RESOLUTION NO. 21-2021

Harrisburg Redevelopment Authority

Preliminary Proposal

Excerpted from email correspondence from Geoffrey Knight Planning to Mr. Knight, 5-18-21

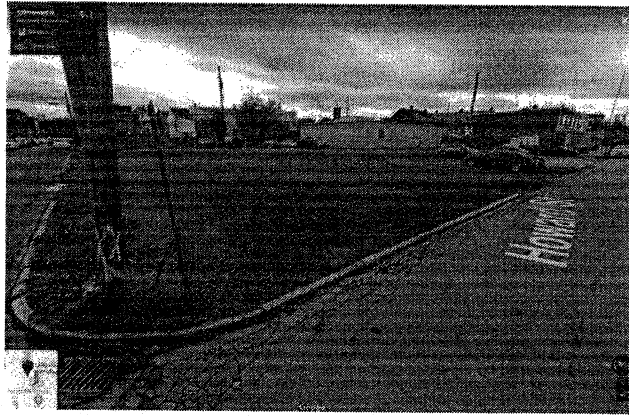
1. The properties can be utilized as an accessory surface parking lot, as they are and have been used for that purpose for an extensive history; however, we would require the parking lot to be paved, as we do not permit gravel parking lots since they cannot be lined with spaces that conform to the Zoning Code. I'd also note that Capital Region Water does not consider gravel to be a pervious surface for the purposes of stormwater management – the entire lot would be considered to be impervious. I would also note that there are parking lot design guidelines in Sections 7-307.11, 7-307.12, and Chapter 7-327 of the Zoning Code, and that the proposed parking lot would need to meet all applicable regulations, such as ADA spaces and screening. The Planning Bureau considers aspects such as encroachment into setbacks and impervious surface coverage (outlined in Section 7-307.3 of the Zoning Code) to be existing, non-conforming aspects that can be continued going forward, although we would require the screening as noted above. If you can't/don't want to install all the required trees on the site, the Zoning Code allows the installation of those trees in tree pits in the right-of-way (sidewalks) in the surrounding neighborhood, and we can discuss which might be best for this project.

2. This issue can largely be addressed by the response to Item #1 (above)...
5. The two properties are located in the Industrial (IND) zoning district; per Section 7-307.9(f) of the Zoning Code, a seven-foot-high fence of the type identified in the proposal would be permitted by right.

- While not required, I would recommend that you consider filing a Lot Consolidation Plan for 1365 Howard Street & 72 South 14th Street to combine them into a single parcel, as it would "clean up" the site from a parcel perspective. Again, this is not required, but I would recommend considering this. If you decide to go through with that, I can provide the required documentation and outline the process.
- Please ensure that the sidewalks along the Howard Street and South 14th Street frontages (see below) are reconstructed and that site access is provided via a formal curb cut and driveway. I have included the City Engineer, Wayne Martin, on this response as his department is responsible for managing right-of-way improvements.

- The installation of the fence and paving of the parking lot would require the filing of a Building Permit application (attached) with the Codes Bureau.
Please let me know if you have any other questions.
